## Architectural Review Board

### Meeting Minutes

October 8, 2018

**ARB-67-2018 Certificate of Appropriateness  
Certificate of Appropriateness for new signage at 160 W. Main Street for Columbus  
OBGYN (PID: 222-004559).  
Applicant: Signcom Inc. c/o Bruce Sommerfelt**

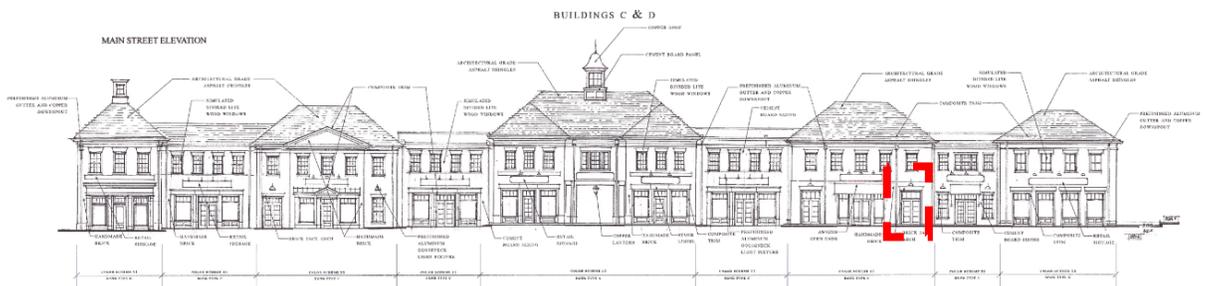
The proposed sign is consistent with the other wall signs and projecting signs’ designs within the Market Square area. While the proposed wall sign is an appropriate sign type for this location as the stairwell entrance leads directly to the tenant space, staff recommends the ARB confirm with the applicant the lighting plan for the sign to ensure there is enough space for the sign and the additional gooseneck lighting.

The sign board is two feet in height which is consistent and matches all other sign boards on this buildings. However, the sign’s width does not appear to be appropriately scaled for the space since it is wider than the door frame but not centered over it due to

an existing drain pipe. Staff recommends the sign board is narrowed in length so it matches the width of the door's soldier course arch.

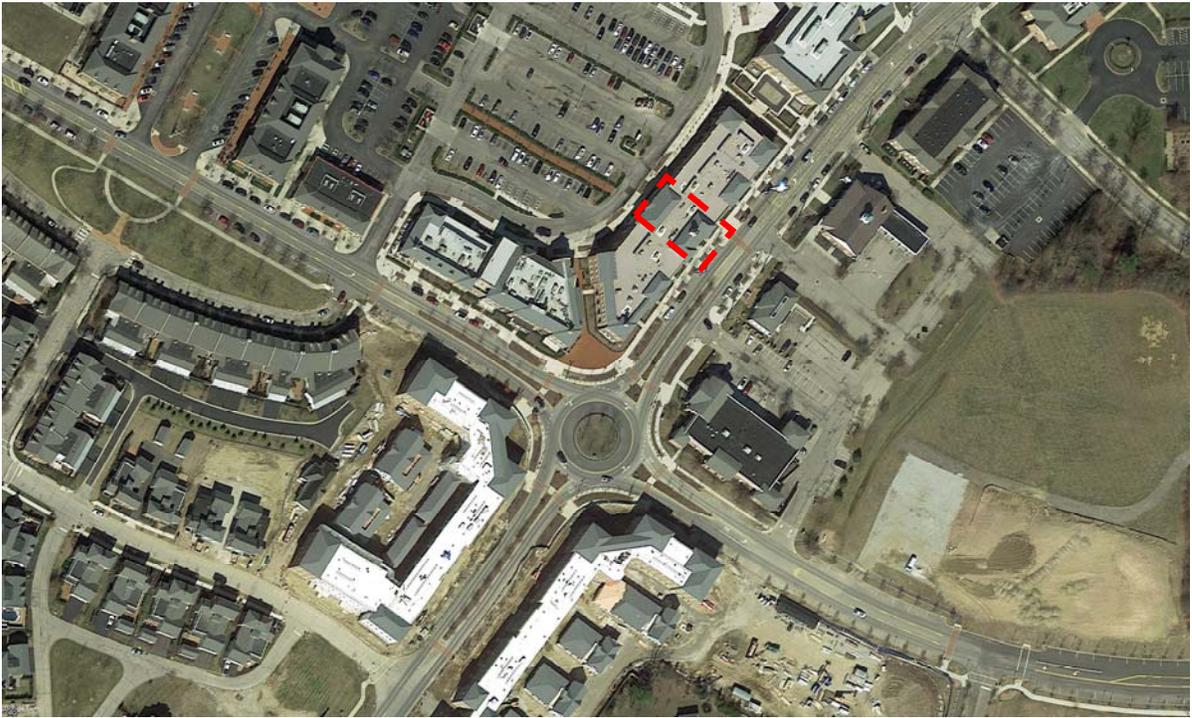
- The window signs appear to be appropriately located on the building. Similar window signs have been previously approved by the Architecture Review Board in other locations in the Market Square area. The proposed signs are pedestrian scaled and provide interest along the Market and Main walkways.

Staff recommends approval of the certificate of appropriateness application, provided that the ARB finds the proposal meets sufficient basis for approval. The signs meet all of the standards in the City Sign Code and are appropriately designed for the window spaces.
